PLANNING & ZONING AGENDA ITEM #5

SUBJECT: Approval of a Rezoning request by amending the Planned Development for Williams Pointe Plat 9 including modification of the underlying zoning district of C-1A [Neighborhood Commercial District]/R-3 [Rental Multi-Family Residential District] to C-4[Office Park Commercial District]

RE: Williams Pointe Plat 9 PD Amendment & Williams Pointe 7 Rezoning (Access Systems)
Submittal #2

RE: Williams Pointe Plat 9 PD Amendment & Williams Pointe 7 Rezoning: Access Systems

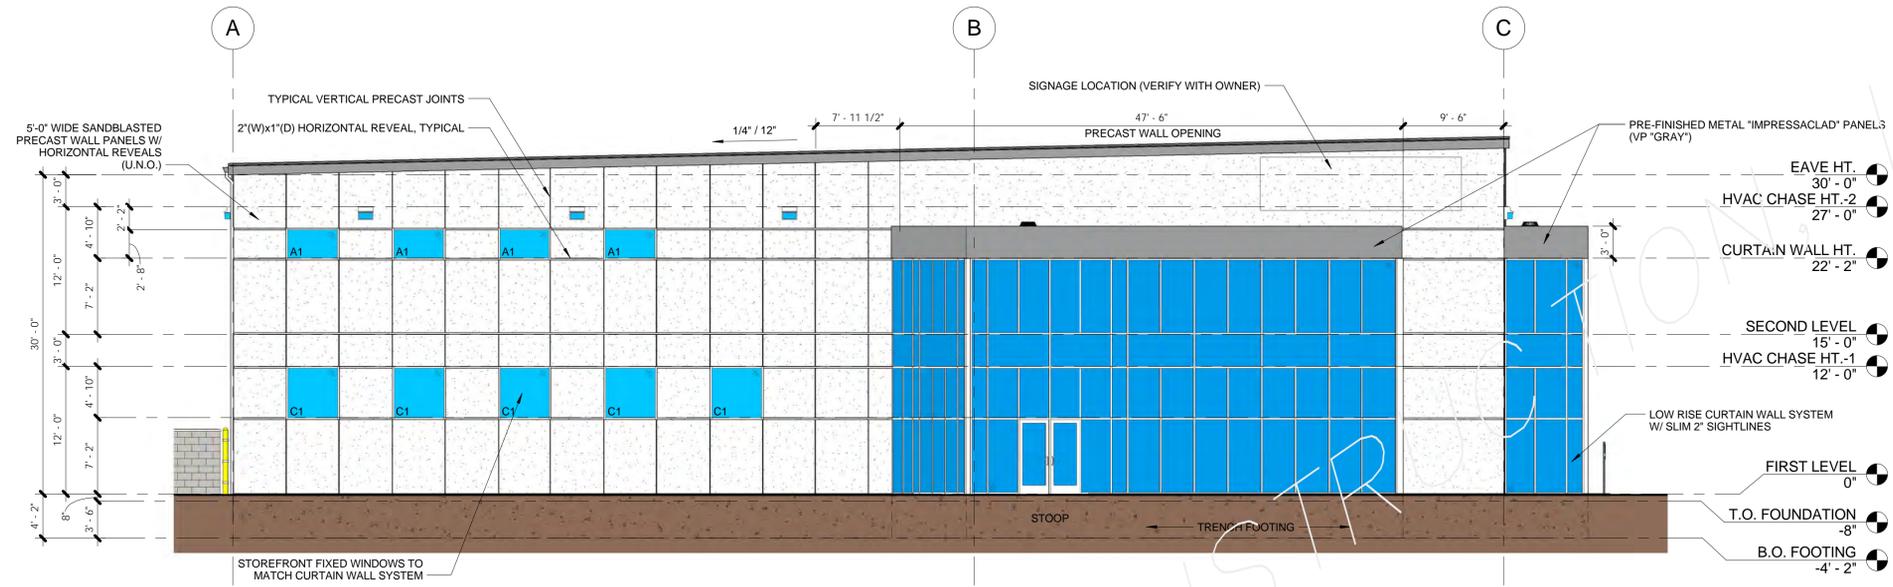
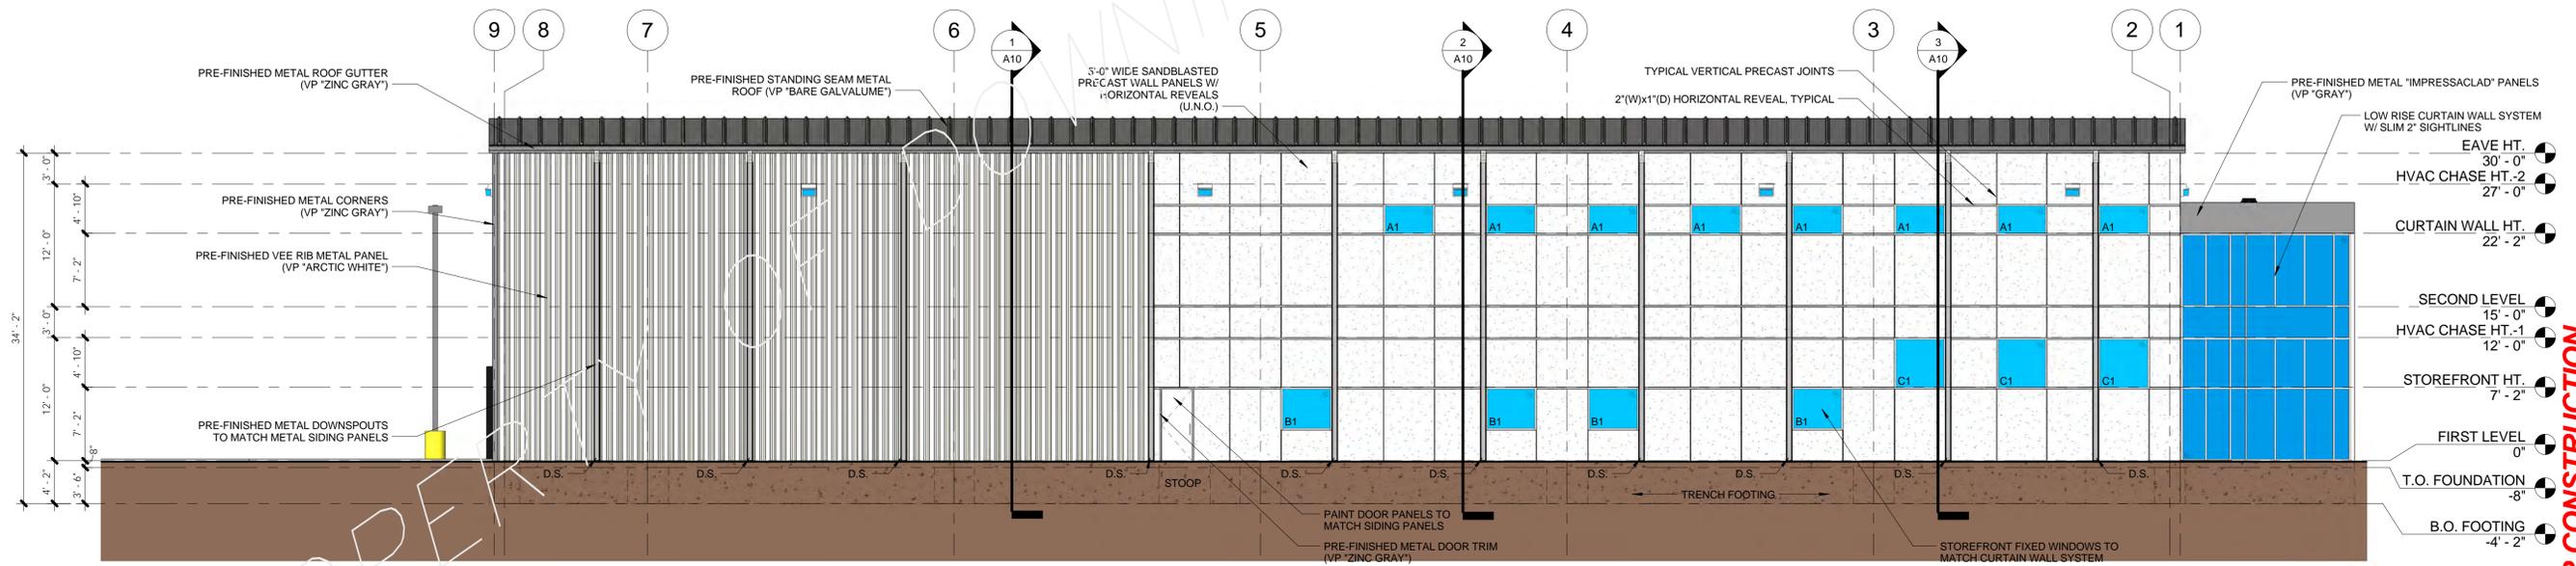
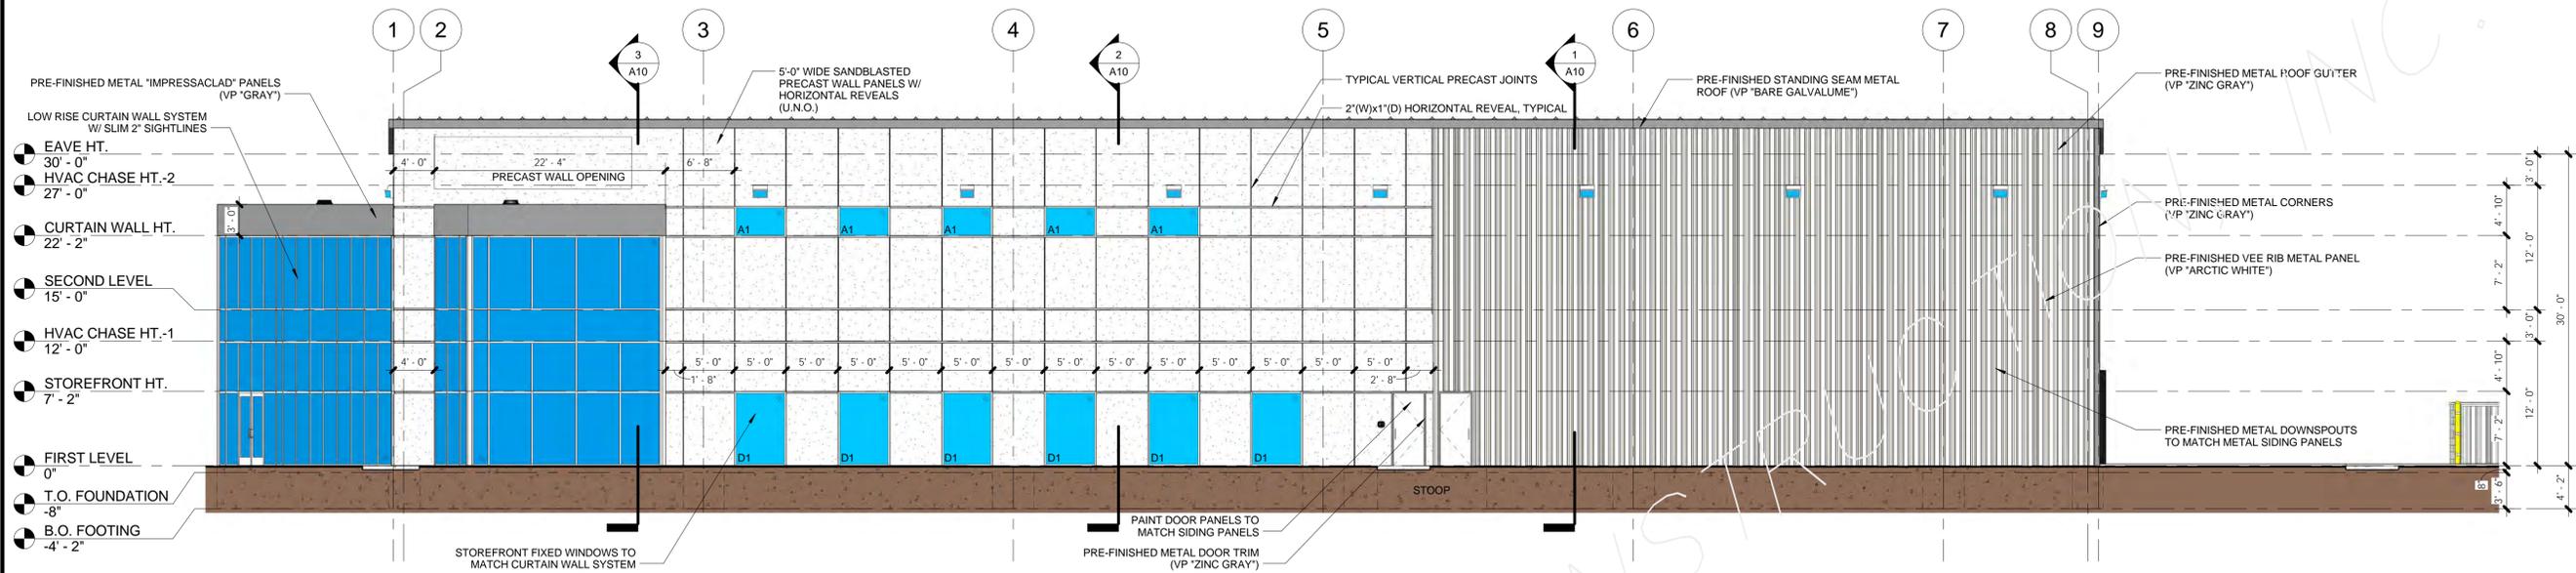
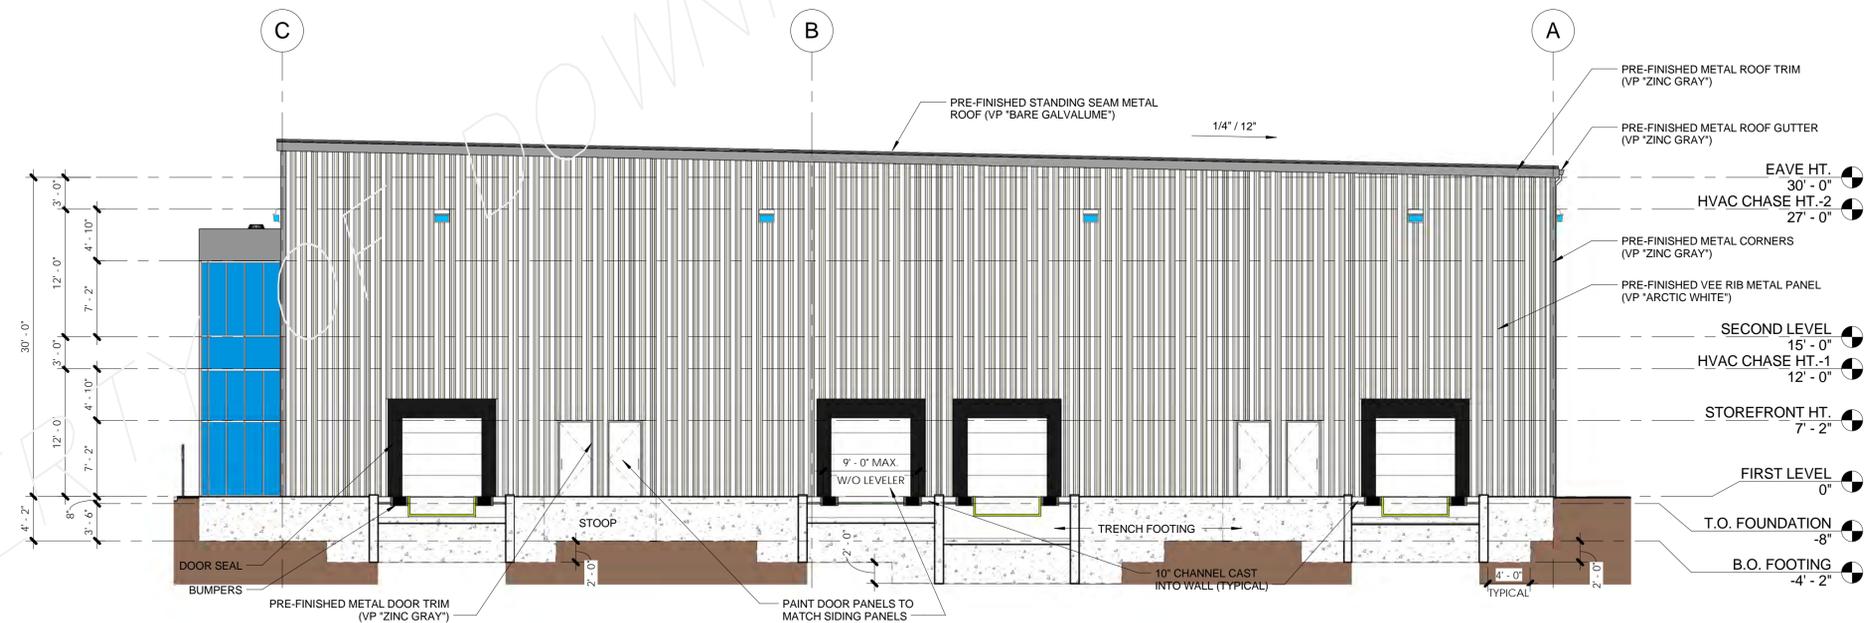
12. Colored Elevations of all 4 sides of the building should be provided in PDF form for inclusion in the amended planned development document.

13. Staff would note that as part of the zoning and site plan consideration, additional creativity and thought should be given for the planned exterior surface proposed along the warehousing component of the building to better align with the Site Plan Ordinance. Staff has provided the ordinance reference and Architectural Design Example Book for use to the applicant's design professionals and would encourage this item to be addressed prior to review of the proposal by the Planning and Zoning Commission or City Council. Please address.

A PDF of colored elevations is included with this submittal.

This comment is duly noted. The Applicant and his designer are looking at this further. We will supply revised elevations upon further coordination.
